**PLANNING COMMISSION
STAFF REPORT**

June 20, 2024

AGENDA ITEM: Planning File No. **MAJ-23-0011**, a final review of a Major Site Plan application for a new mixed-use/affordable housing development.

LOCATION: 101 W Main Street / LOT B-1 WEST FRISCO 70 SUB # 2

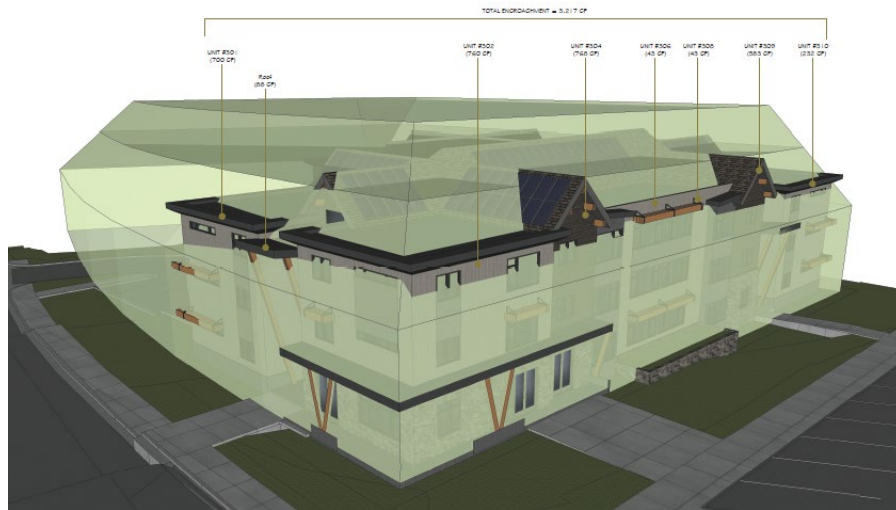
Refuse Management (§180-6.17): All commercial, mixed-use and multi-family residential development projects containing five (5) or more units shall utilize dumpster enclosures for the storage of all refuse, recycling, grease traps, and compost collection. The application materials show a trash enclosure in an accessible location and is proposed to have materials consistent with the primary structure on site. The application meets this requirement.
